**Addendum No. 4
BL012-24**

Lanier Filter Plant Dewatering Building Modifications and Chemical Improvements

The following addition/changes modify the Bid No. BL012-24 "Lanier Filter Plant Dewatering Building Modifications and Chemical Improvements" Contract Documents, dated December 2023, as first advertised on December 20, 2023.

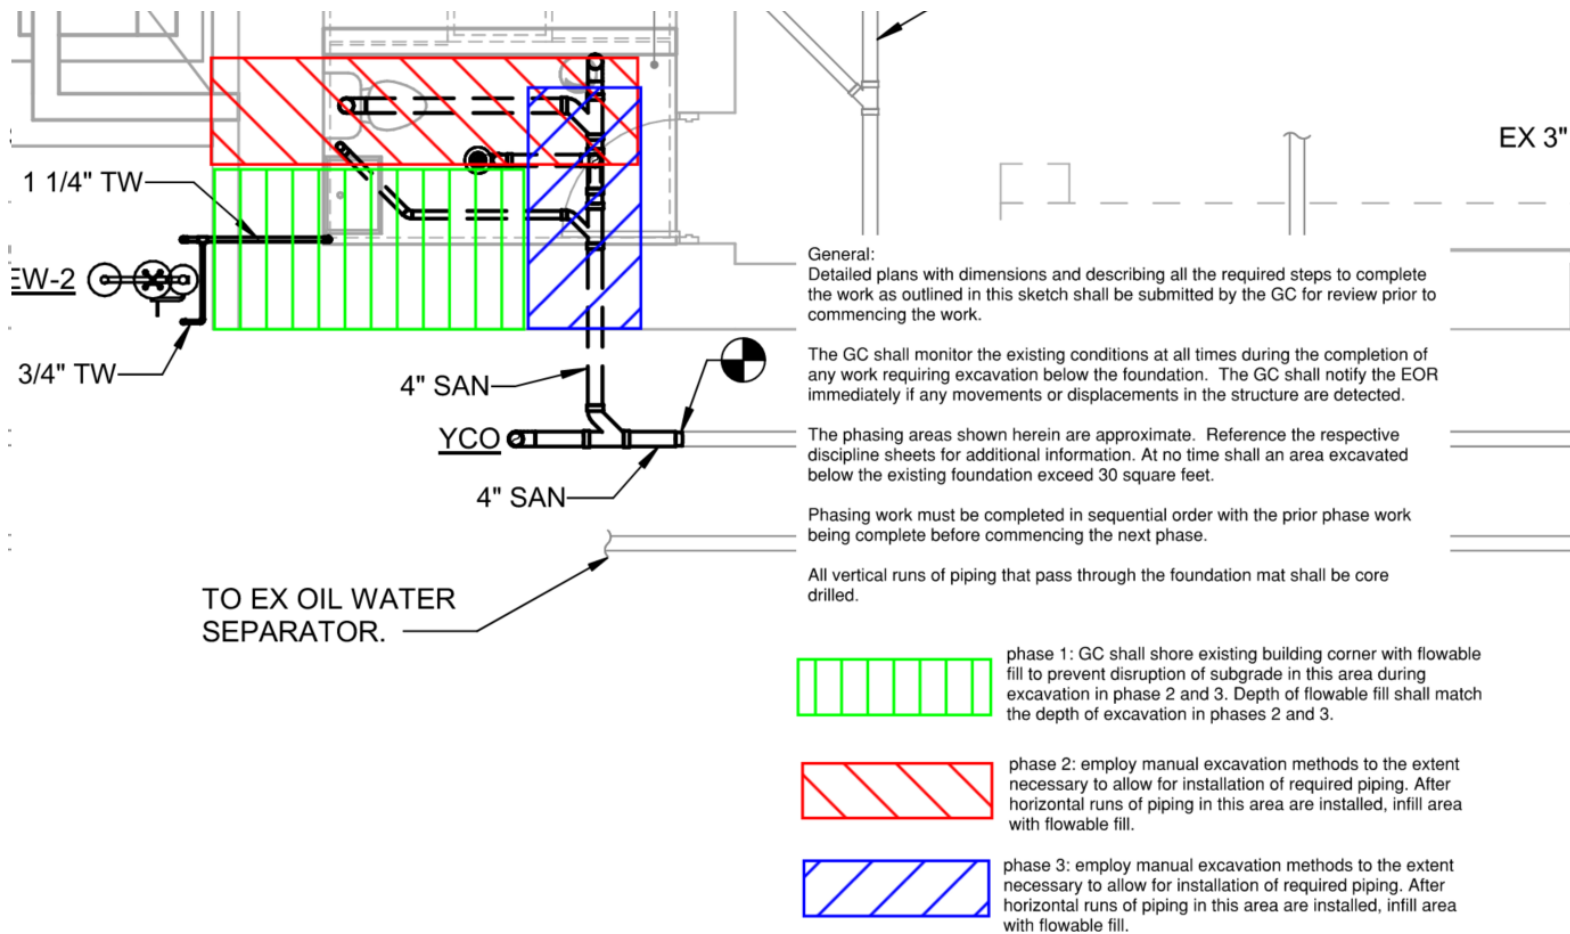
Q2. See Attachment A1 – Lanier Bathroom Slab Question submitted.

A2. See the sketch below. A floor drain has been removed and the buried piping to the emergency safety shower have been adjusted as shown below and in the revised Plumbing sheets attached. These changes and notes will be incorporated into the structural sheet within the conformed drawings issued for construction.

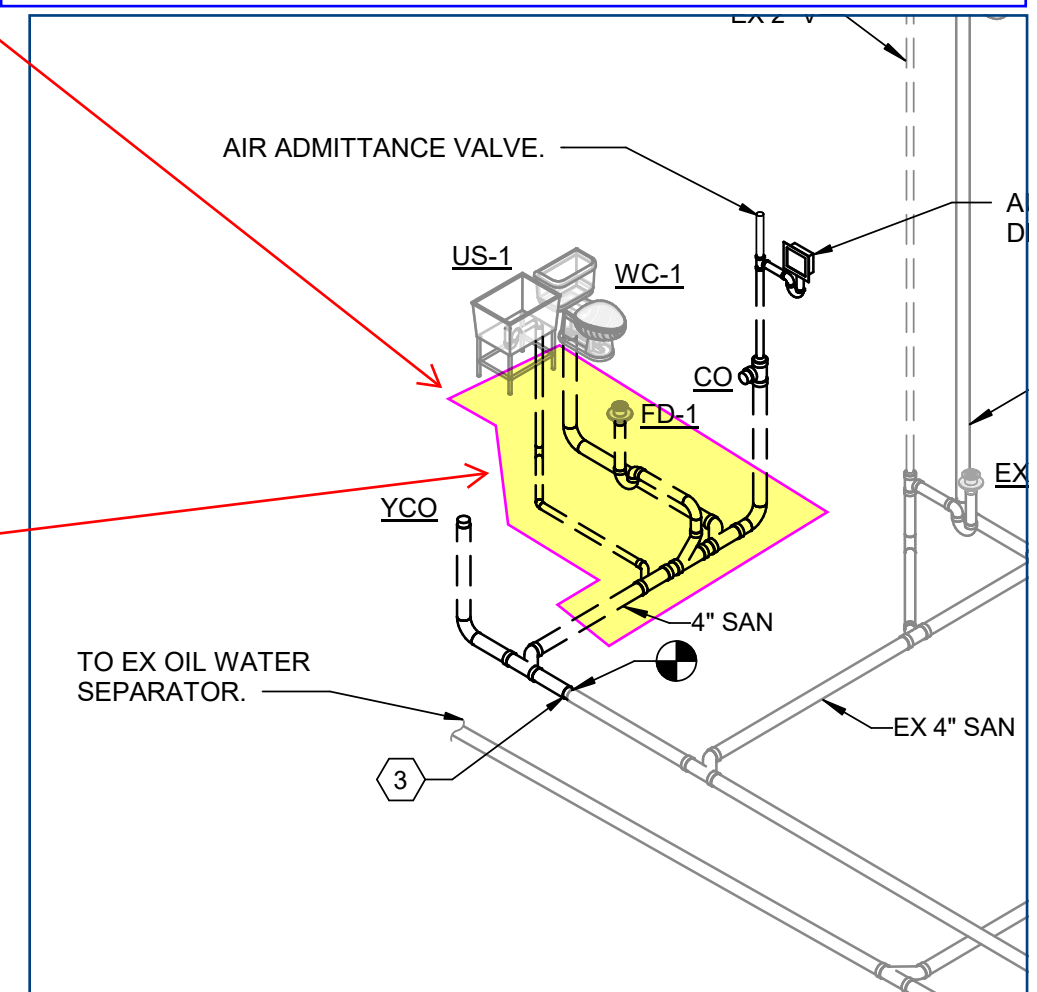
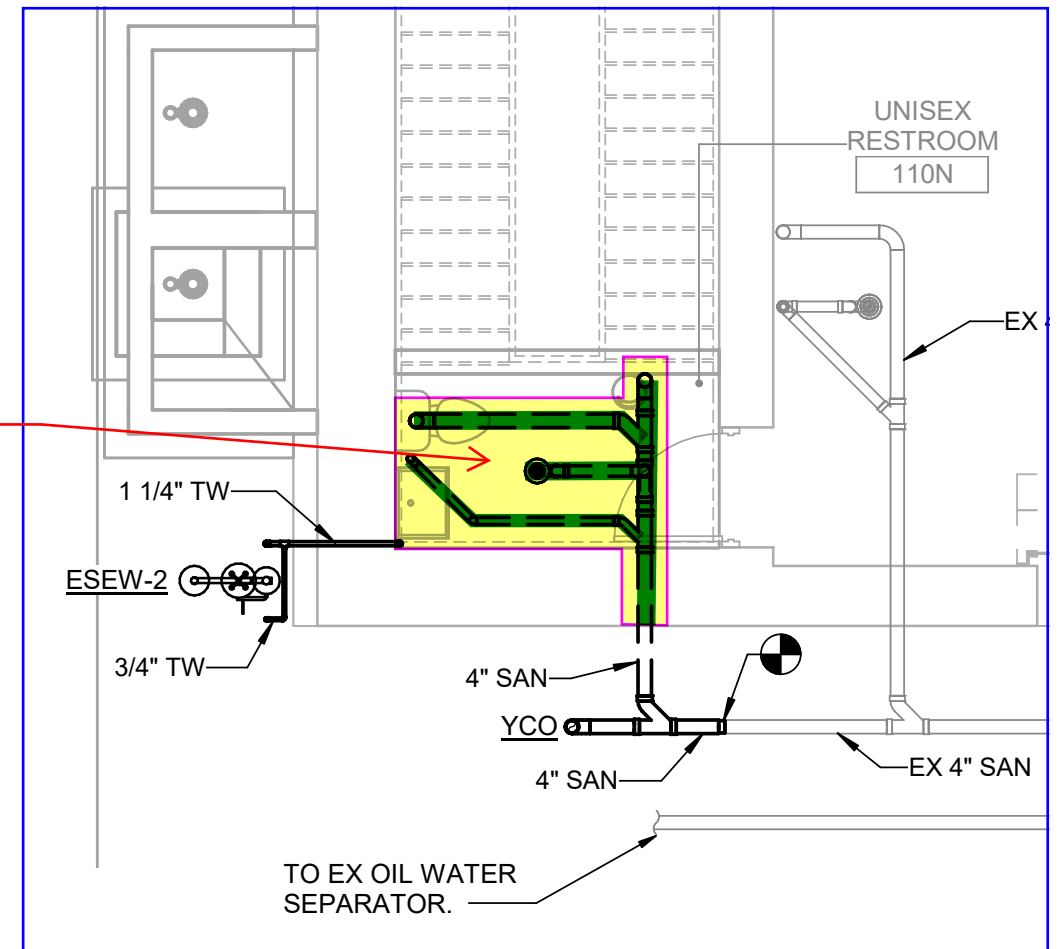
In order to put in 4" SAN pipes portion of existing slab will need to be removed. Exact depth of pipes not known, pipes may need to be lower than bottom of slab. Either way significant portion of existing concrete slab/footer will need to be removed for pipe install and then rebar and concrete placed back without compromising building integrity. Structural details should be provided on replacement of rebar and additional information on scope of work (approx pipe elevation in slab).

Best case is if pipe can remain in existing slab and not go below.

Drawing appears to indicate fair amount of vertical pipe from fixture (top of slab) to horizontal 4" SAN, and would put pipe below slab. Controlling undermining would be challenging and costly work.
